LANEY

L50R

CIRCUIT DIAGRAM

DRAWING No. 1712

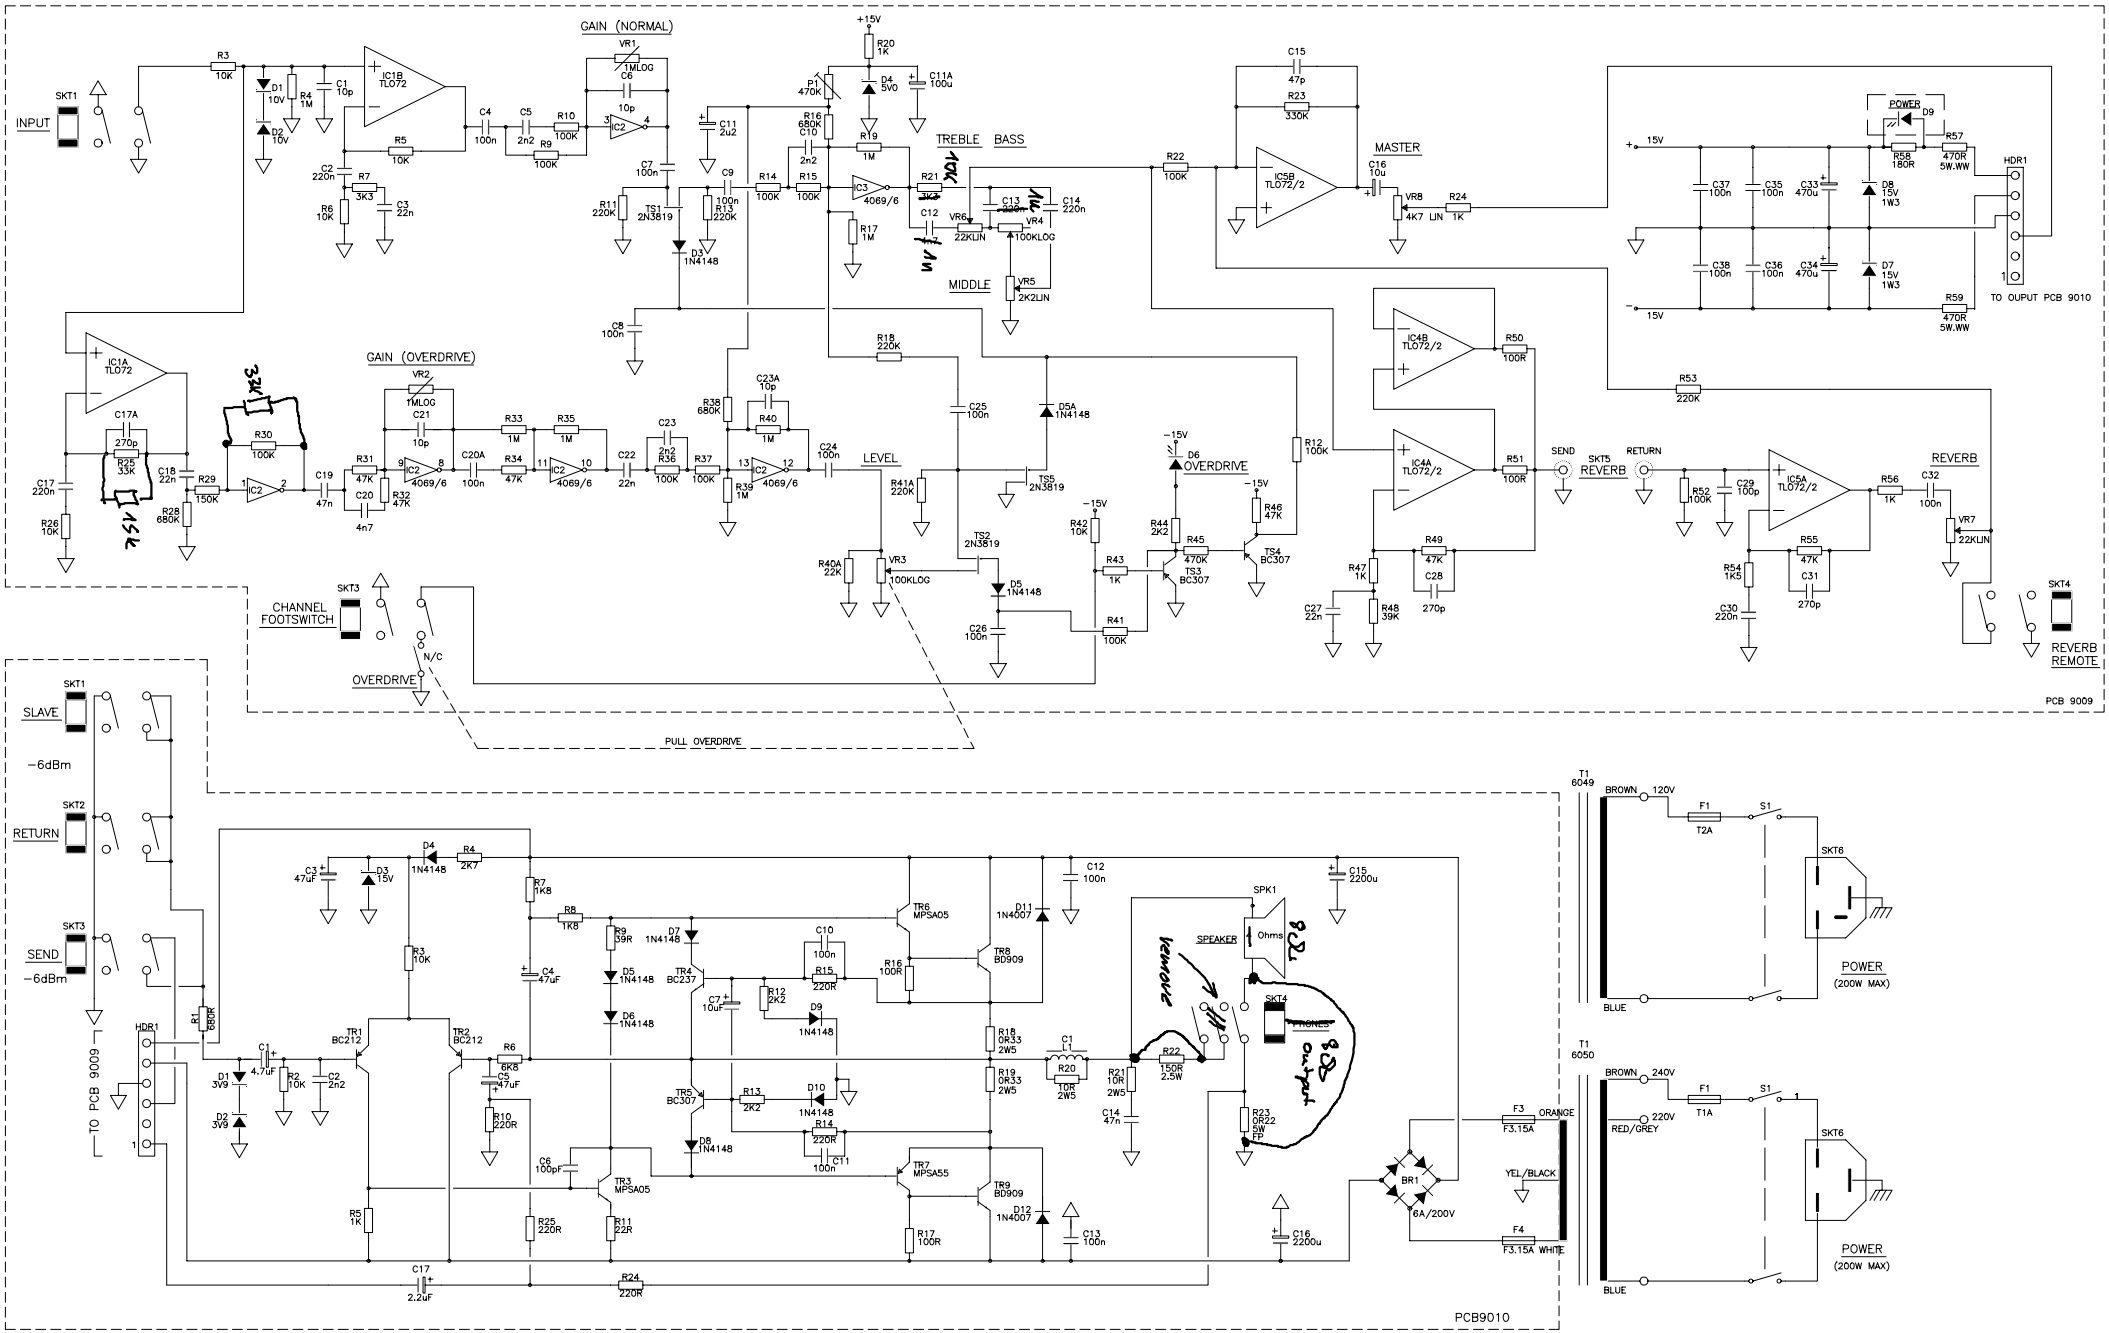
ISSUE	DESCRIPTION	APPD.	DATE
4	VR6 CHANGED TO 4K7 LIN FROM 10K LOG	SJA	22/10/91
3	R14 + R15 CHANGED TO 220R	R.J.F	30/08/91
2	R14 + R15 CHANGED TO 180R	R.J.F	2/08/91
